MD Helicopters, LLC

***MD500/600 Series
Technical Bulletins Package***

This package contains a complete set of
all Technical Bulletins issued through:

22 August 2023

Figure 2. Engine Build-up

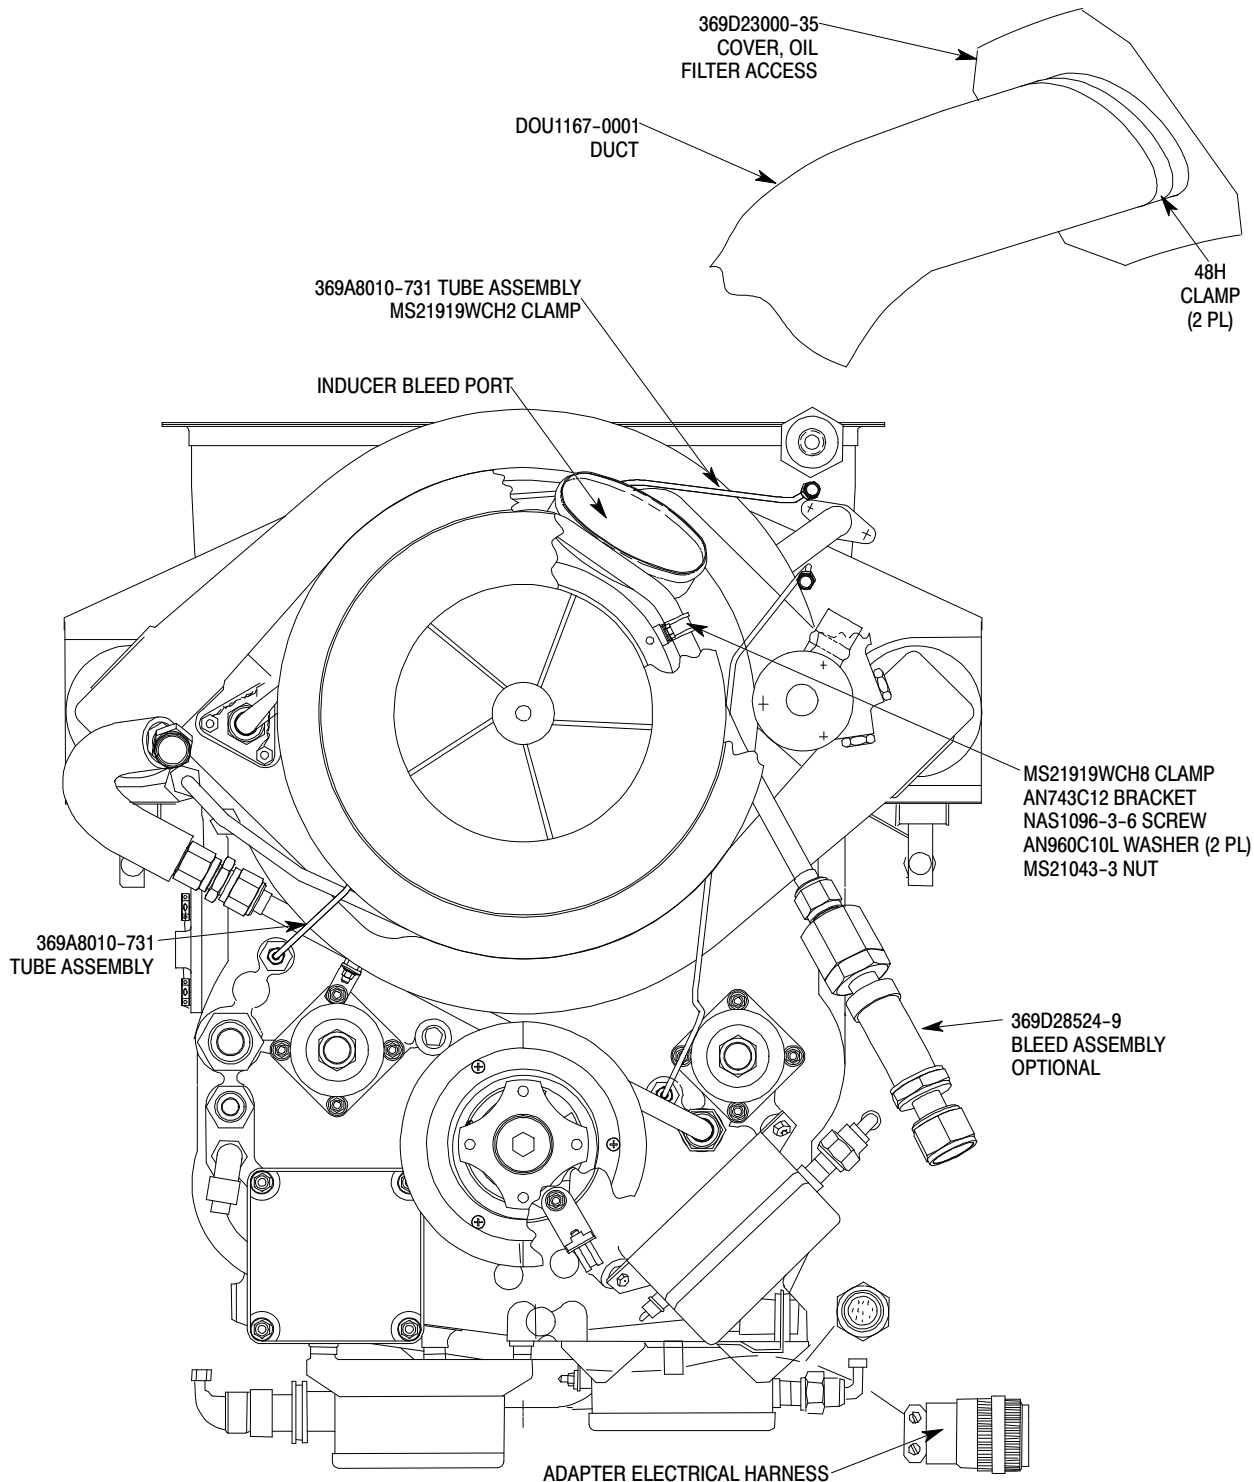
- (1). Build up engine in accordance with CSP-HMI-2, with the following exceptions.
 - (a). If installing 369D28524-9 improved bleed assembly, install.
 - 1). Install MS21919WCH8 clamp, AN743C12 bracket, NAS1096-3-6 screw, AN960C10L washers, and MS21043-3 nut.
 - 2). Install 369A8010-731 tube assembly and MS21919WCH2 clamp. Attach clamp at existing clamp point with existing hardware.

Figure 3. Electrical Modification -513 Aircraft S/N 001 Thru 075

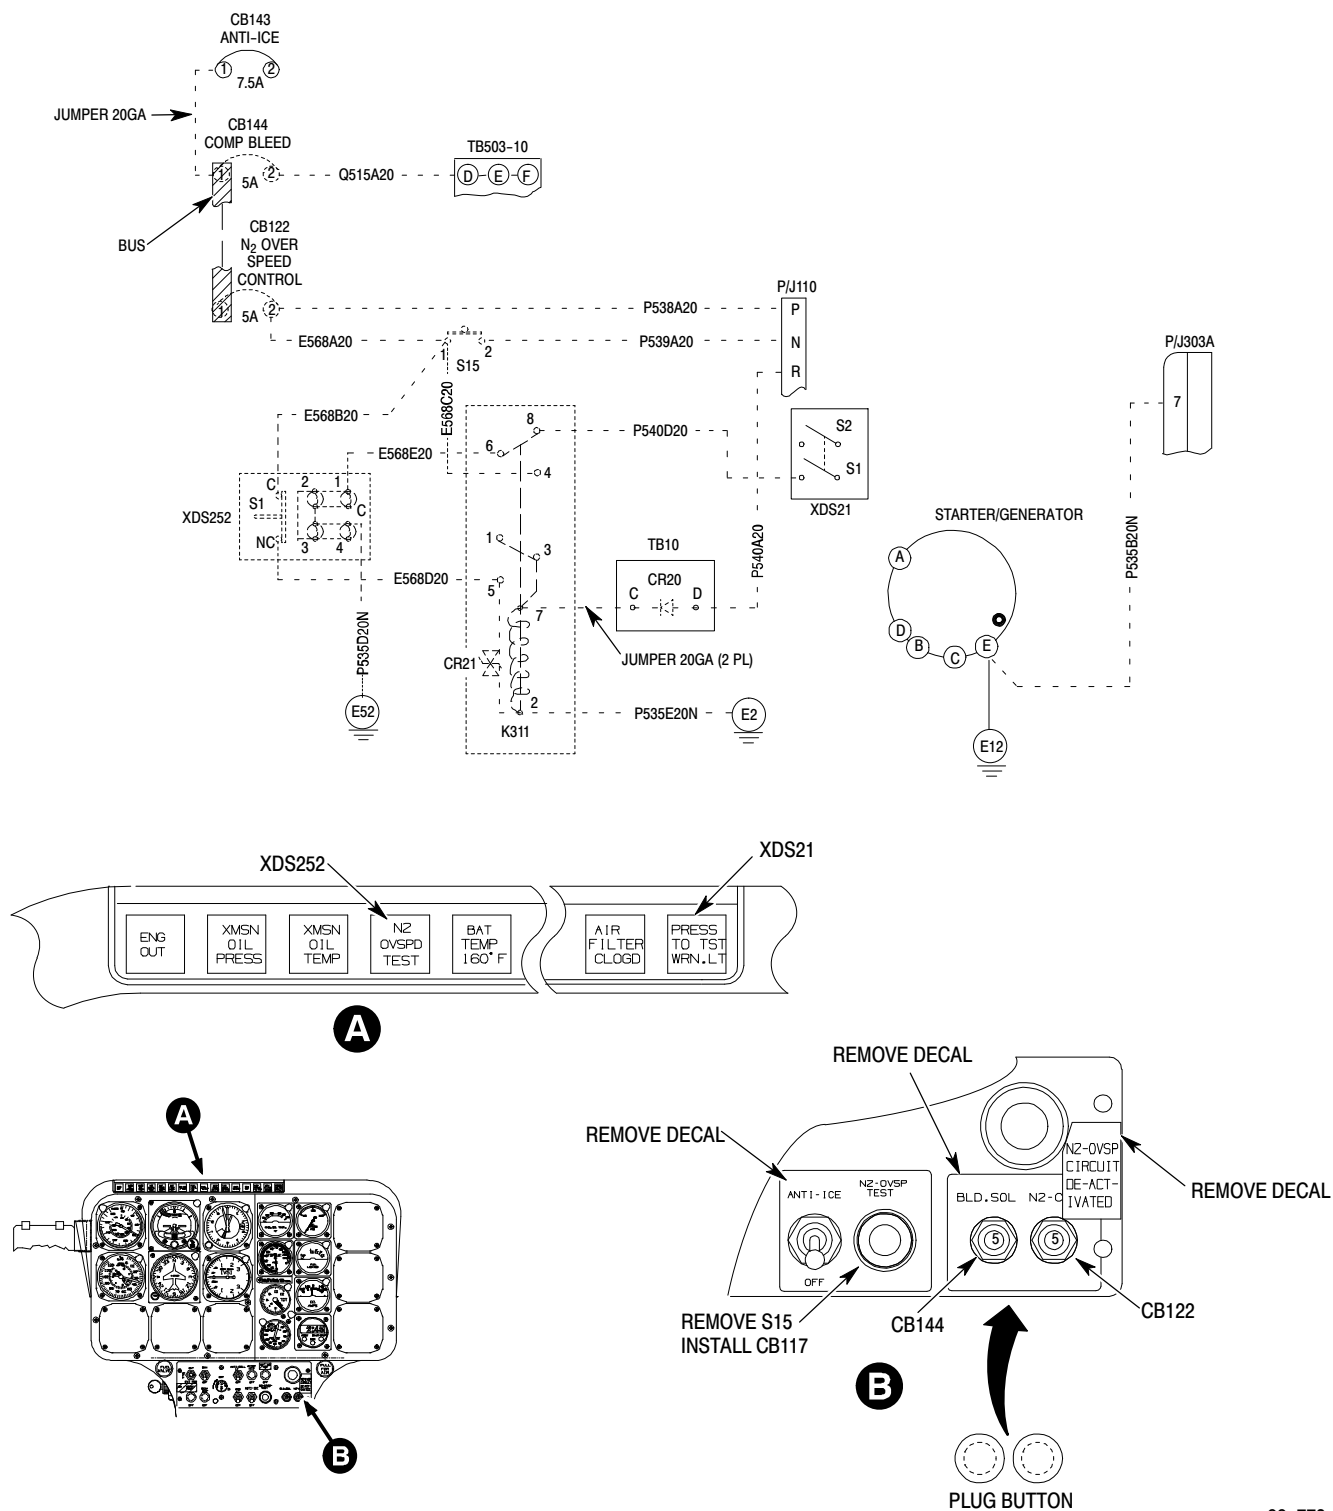
- (1). Remove 20GA jumper from CB143-1 and CB144-1 and discard.
- (2). Remove wire number Q515A20 from CB144-2 and cap and stow.
- (3). Remove wire number P538A20 from CB122-2 and cap and stow.

Figure 4. Electrical Modification -511 Aircraft S/N 076 Thru 133

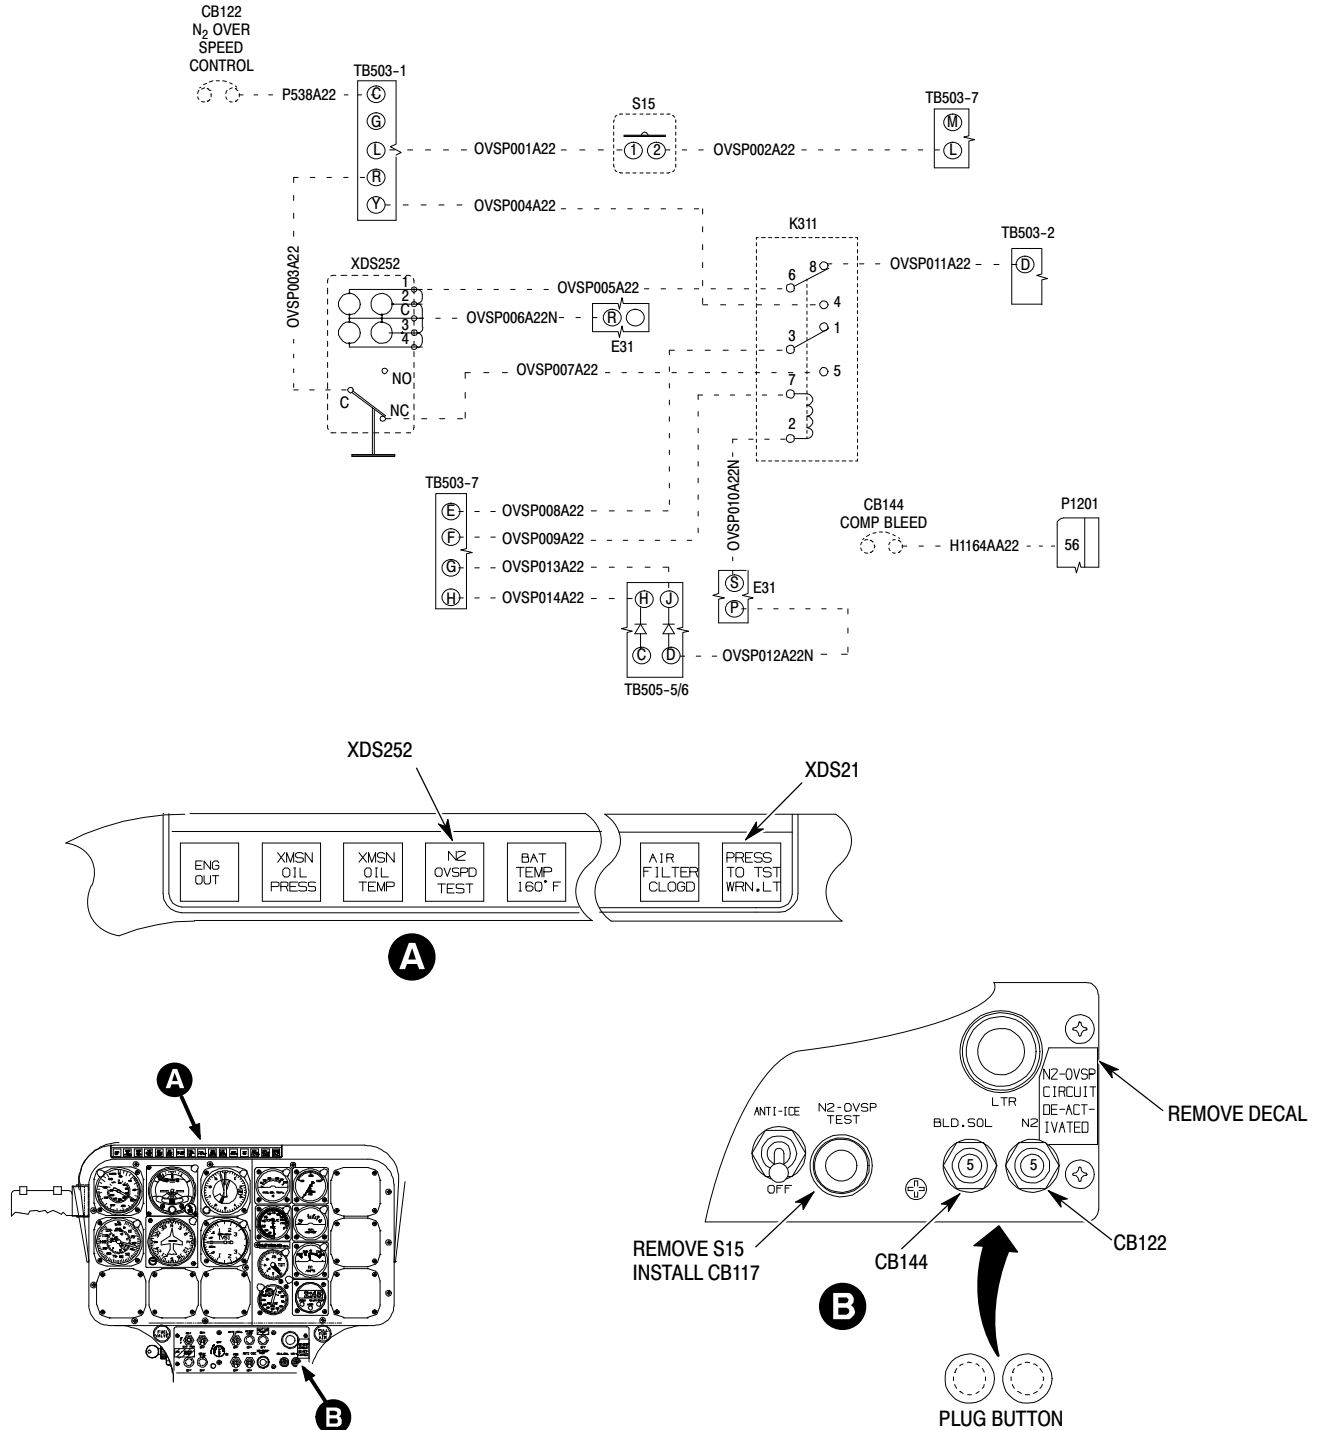
- (27). Remove K311 (Overspeed Relay) and discard.
- (28). Remove wire number OVSP012A22N from TB505-5/6D and cap and stow.
- (29). Remove wire number OVSP013A22 from TB505-5/6J and cap and stow.
- (30). Remove wire number OVSP014A22 from TB505-5/6H and cap and stow.

Figure 4. Generator Cooling Scoop and Duct Installation

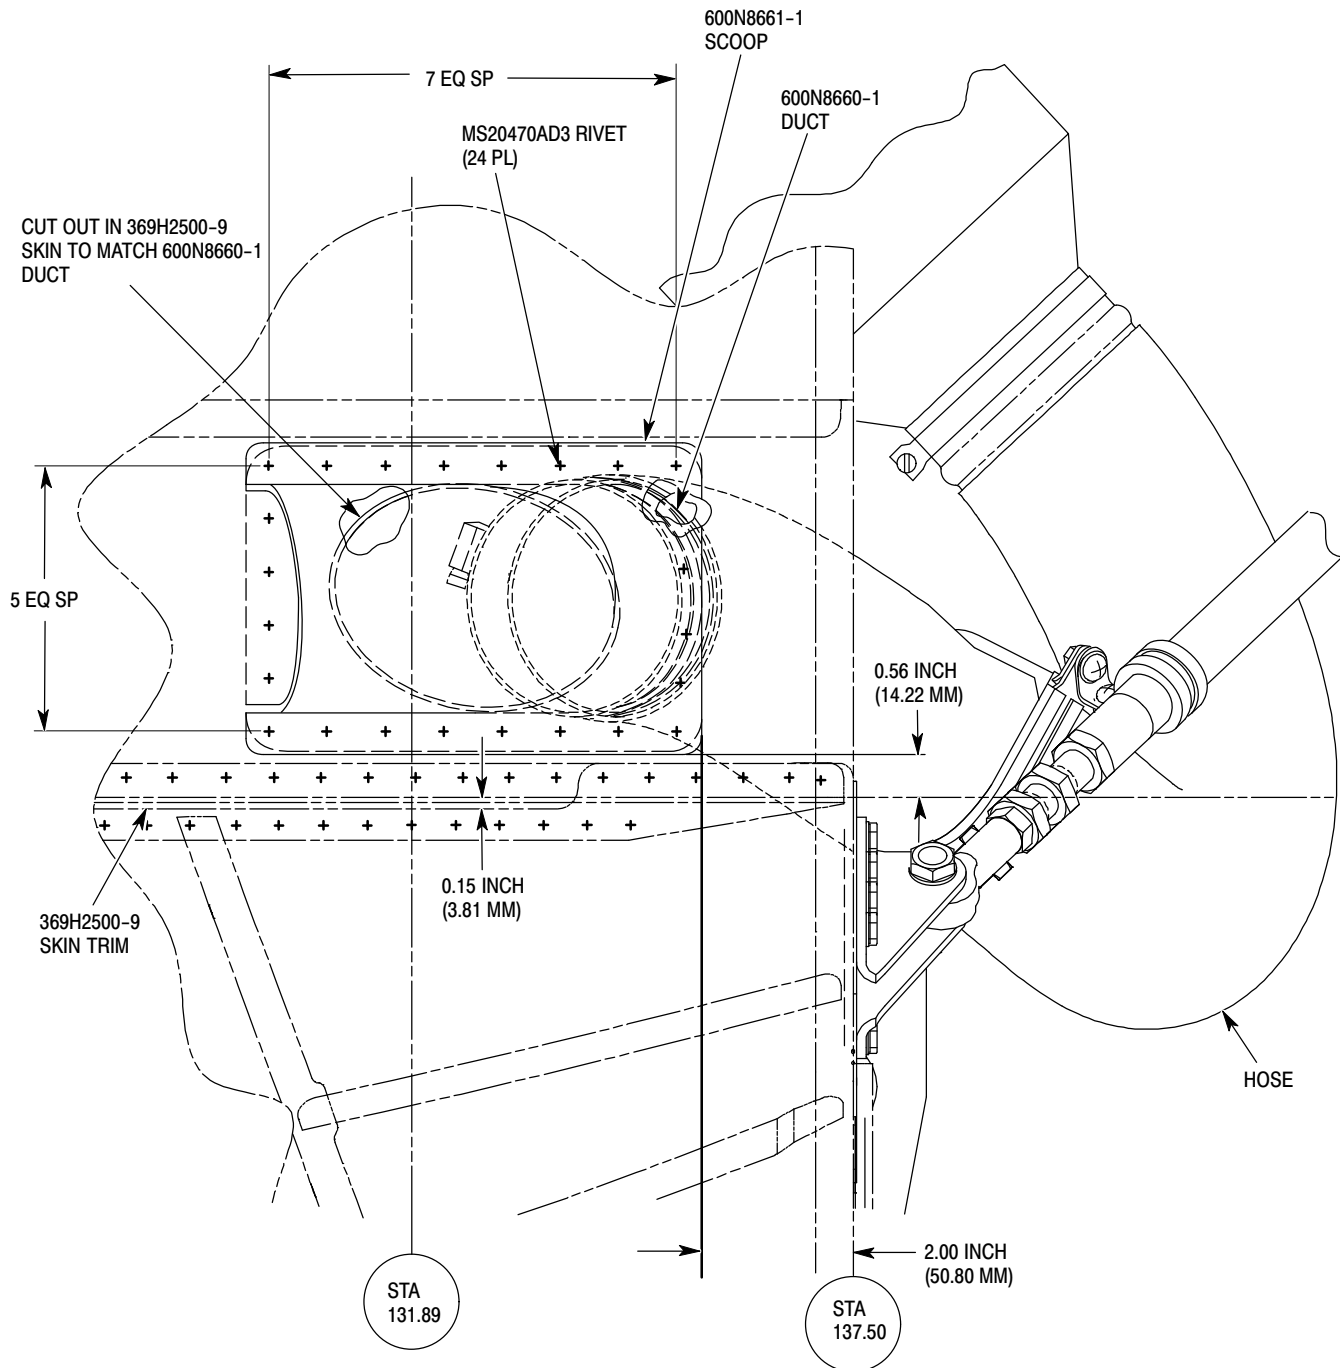
- (4). Prepare 600N8660-1 Generator Cooling Duct
 - (a). Mark the perimeter of the generator cooling duct mounting flange with new rivet locations.
 - (b). Put the new rivets 2D + 0.030 inches (0.76 mm) from the edge of the flange. Space rivets as shown in Figure 4.

- (e). Put the generator cooling duct against the 369H2500-9 fuselage skin and position it to the location and dimensions shown in Figure 4.
 - (f). Transfer the rivet holes in the generator cooling duct onto the fuselage skin.

- (j). Use the generator cooling duct as a pattern and trace the interior of the generator cooling duct opening onto the fuselage skin.
 - (k). Remove the generator cooling duct and cut out the opening in the fuselage skin as shown in Figure 4.

- (b). Align the parts as shown in Figure 4.
 - (c). Drill the rivet holes in the generator cooling scoop for MS20470AD3 rivets.
 - (d). Clean and deburr the rivet holes in the generator cooling scoop.

Figure 5. Hose and Clamp Installation

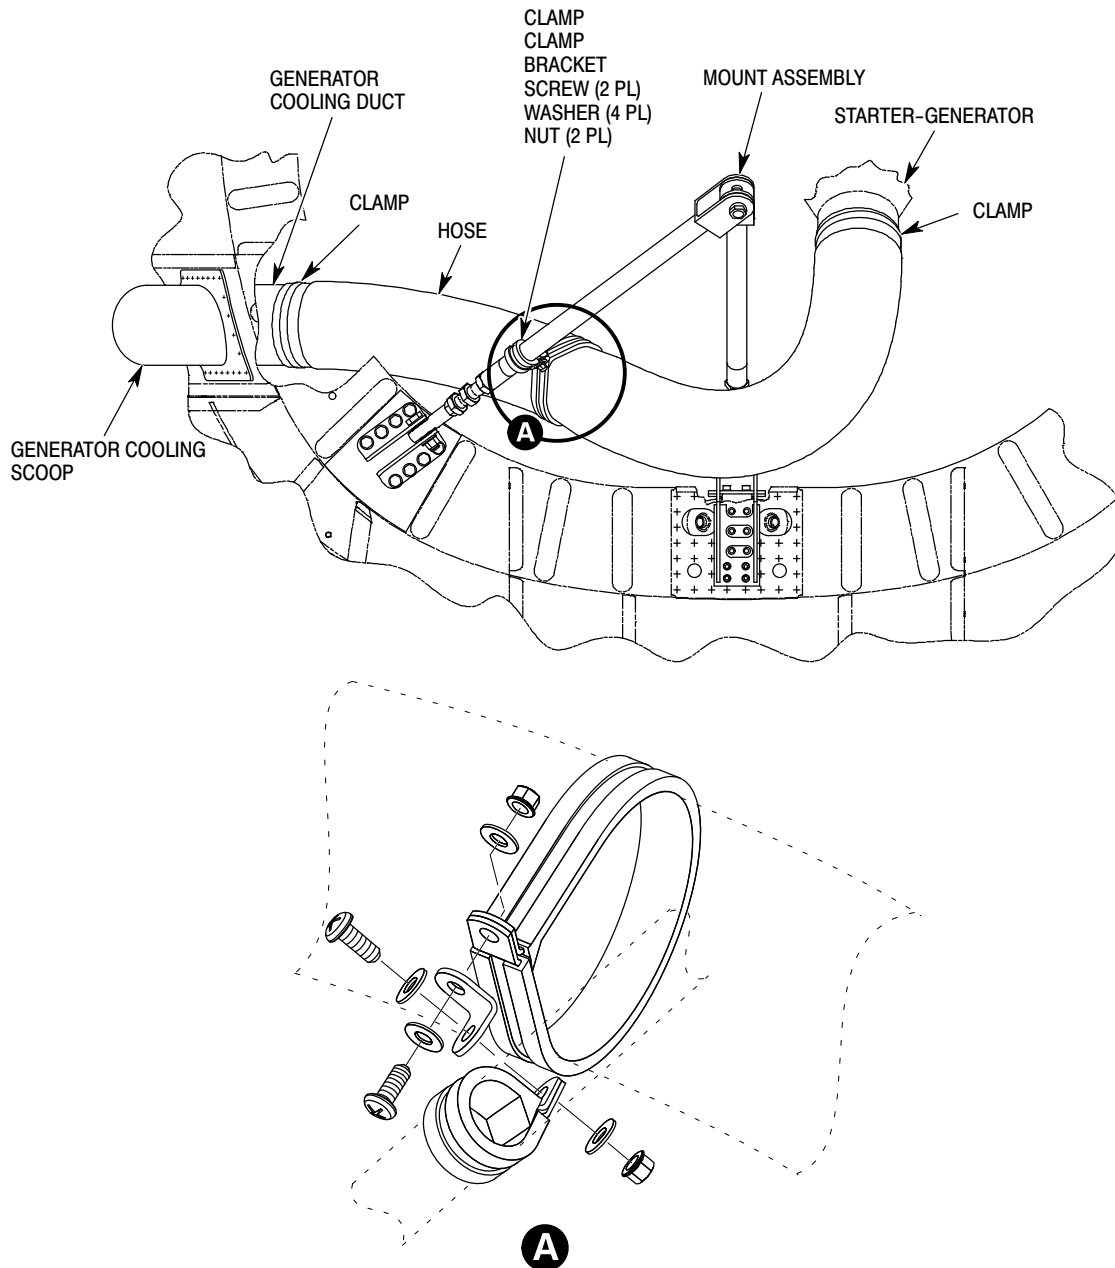
- (a). Put a clamp on each end of the hose.
- (b). Put the hose through the mount assembly as shown in Figure 5.

- (c). Put the hose on the starter generator and attach it to the starter generator with the clamp.
- (d). Put the hose on the generator cooling duct and attach it to the generator cooling duct with the clamp.
- (e). Put the small clamp on the mount assembly strut and position it as shown in Figure 5.
- (f). Put the large clamp on the hose and position it as shown in Figure 5.
- (g). Attach the clamps to the bracket with two (2) screws, four (4) washers and two (2) nuts as shown in Figure 5.
